PERMISSIVE CHANGE LETTER

This **permissive change letter** concerns the approval OQA-FJRNf022 for the Model FJR Type NF022.

Changes/Differences for Model FJR Type NF022

Top view of
FSALID01A

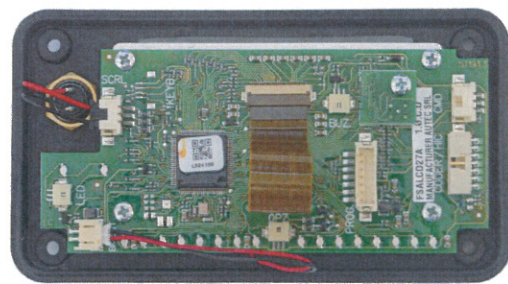
The first change is the **display** used in the transmitting unit. The current display is FSALID01A. The new display will be FSALCD27A with schematic diagram SC000456 (please see the file "sch_FSALCD27A.pdf").

The difference between the two display is memory size: in the new display a more capable one permits more functionalities and more performances.

- 1) all the units will be produced only with the new display and the new electronic starting keyswitch
- 2) the operation of the unit and the working mode for the user are the same with the current and new radio keypad
